ERCOT Independent Review of the AEPSC and Oncor Far West Texas Project

Version 1.0

On April 20, 2016, Oncor and AEPSC submitted the Far West Texas Project (FWTP) to the Regional Planning Group (RPG) to address the transmission needs both in the Culberson loop area and the Barilla Junction area. The proposed project was estimated to cost \$423 million and classified as a Tier 1 project. The proposed in-service date range for the FWTP was 2021-2022.

Based on the FWTP proposal, ERCOT completed this independent review to determine the system needs and address those needs in a cost-effective manner while providing the flexibility to meet potential load and generating capacity growth in this region. ERCOT also performed sensitivity studies in compliance with the ERCOT Planning Guide.

**Figure 4.1: Study Case Thermal Violations in Study area**

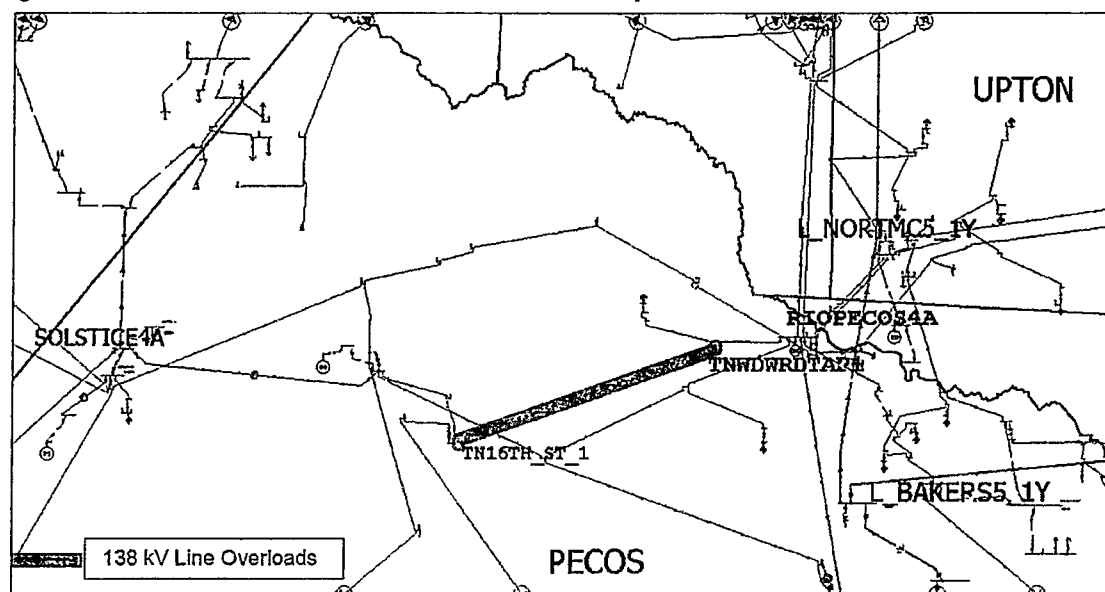
Figure 4.1 shows the thermal violations seen in the Study case.

Both steady state and dynamic stability analyses identified reliability issues under the NERC and ERCOT reliability criteria.

Figure 4.2: Study Case Voltage Violations in Study area

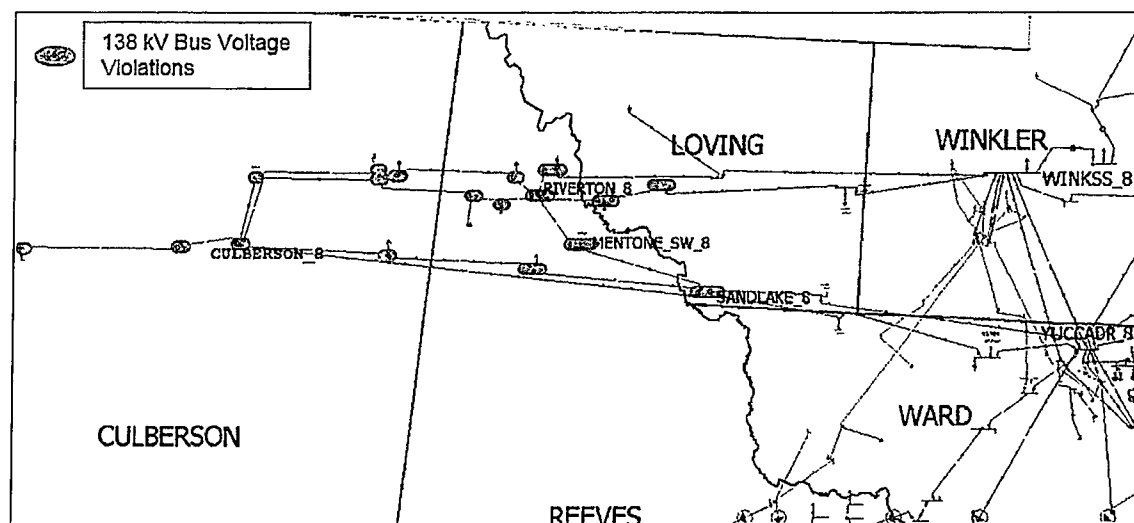
Figure 4.2 shows the voltage violations seen in the Study case.

Figure 4.3: No Solar Case Thermal Violations in Study area

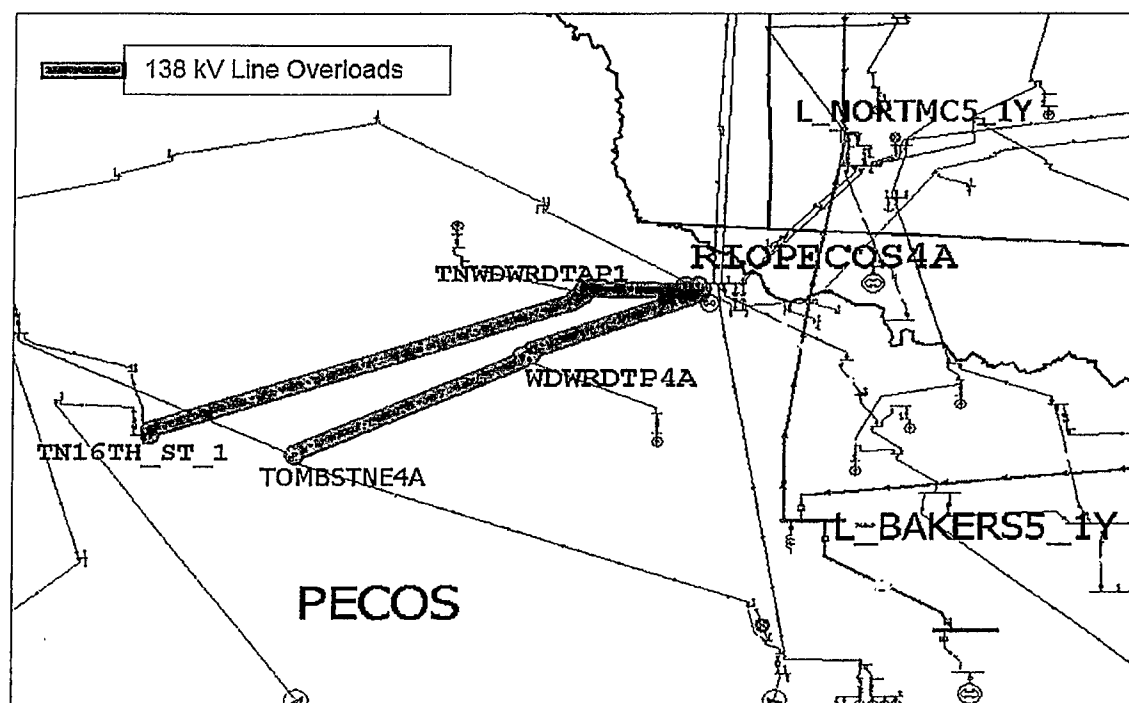
Figure 4.3 shows the thermal violations seen in the No Solar case.

Figure 4.4: No Solar Case Voltage Violations in Study area

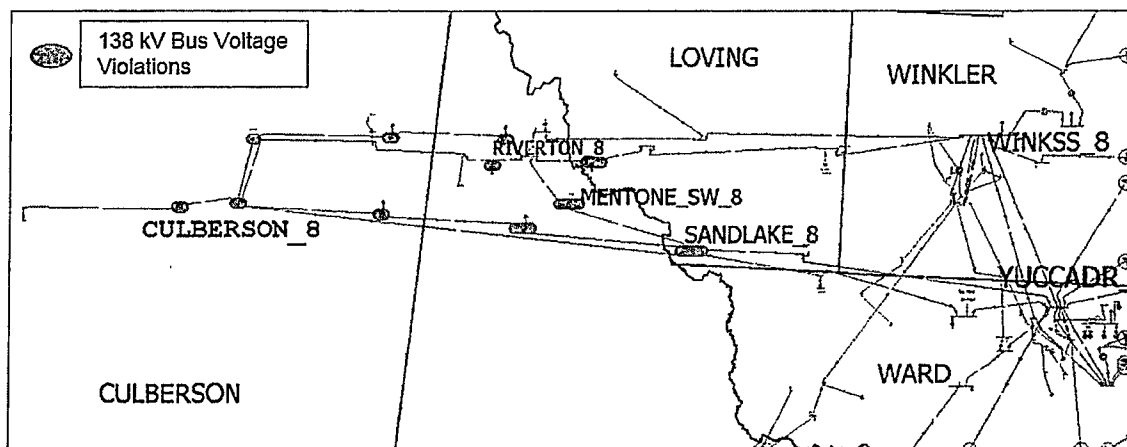
Figure 4.4 shows the voltage violations seen in the No Solar case.

Figure 9.1: Option 2 applied to the Study area

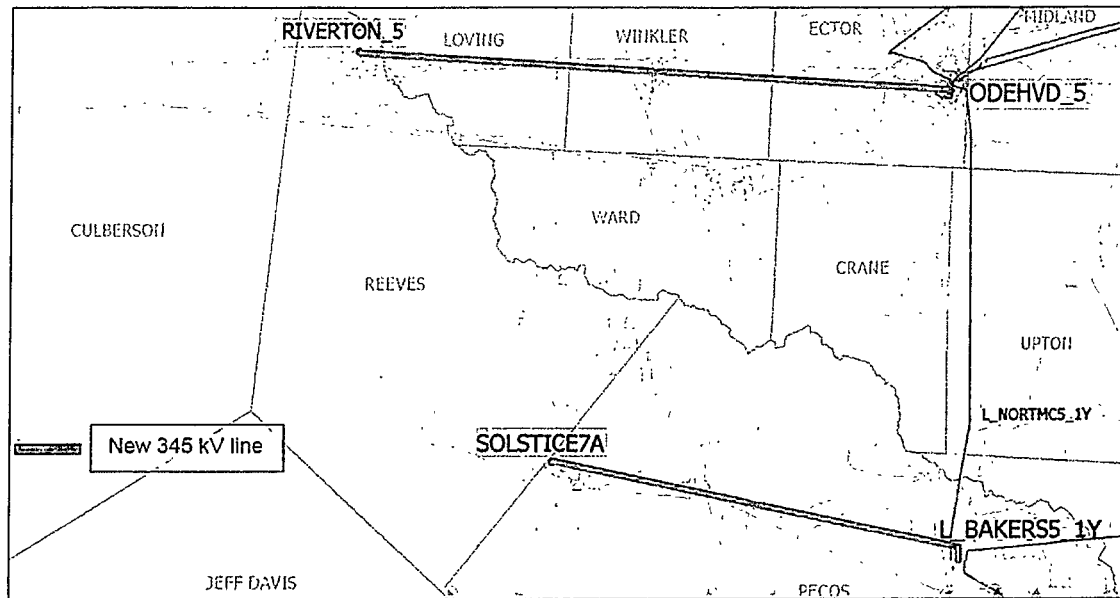
As shown in Table 9.1, a comparison of study results for the short-listed options shows that Option 2 met the system reliability criteria under the Study Case load conditions while deferring more than \$100 million in capital expenditures when compared to the other options. Option 2 also resulted in lower system production costs when compared to Option 1 and was expected to provide an adequate voltage stability margin.

Additional studies were performed to verify that Option 2 will provide the most cost-effective configuration to meet the Study Case load conditions consistent with ERCOT Protocol and Planning Guide requirements.

Figure 9.1 shows Option 2 applied to the study area.

Figure 9.1: Option 3

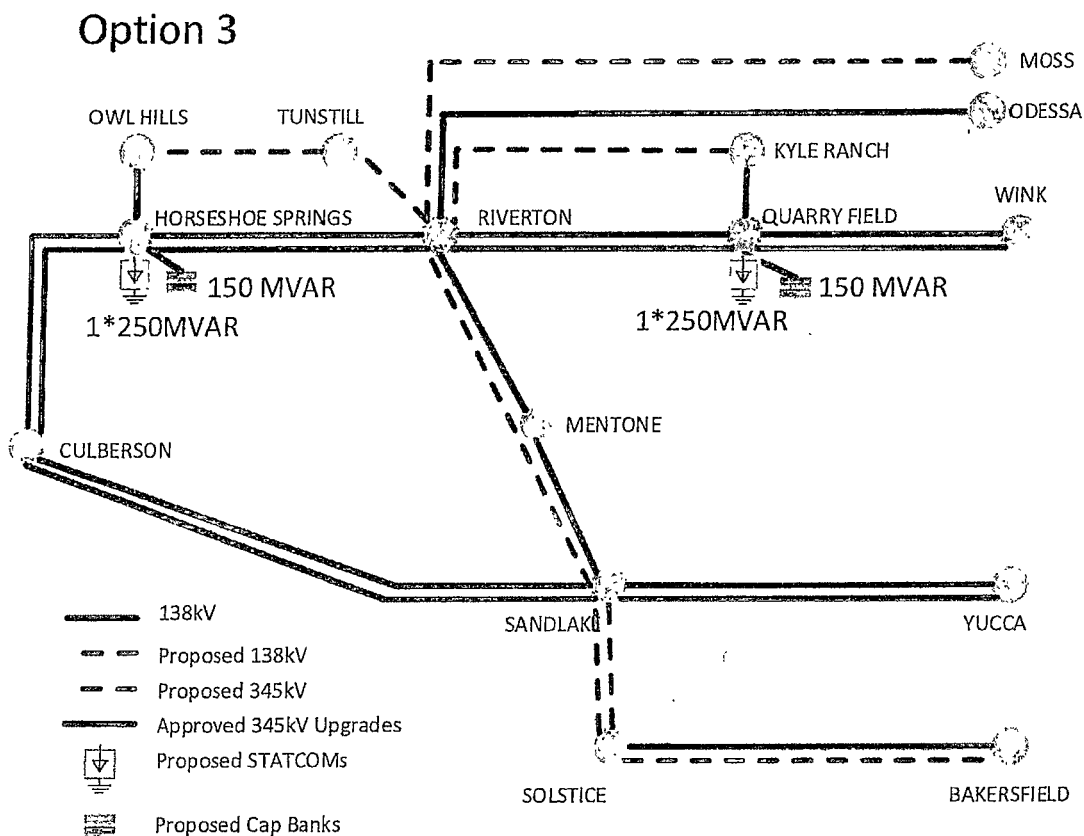
As shown in Table 9.1, a comparison of study results for the three options shows that Option 3, shown in Figure 9.1, met the system reliability criteria under the studied load conditions while providing better load serving capability to accommodate both the near-term and potential future load needs in the Culberson Loop area.
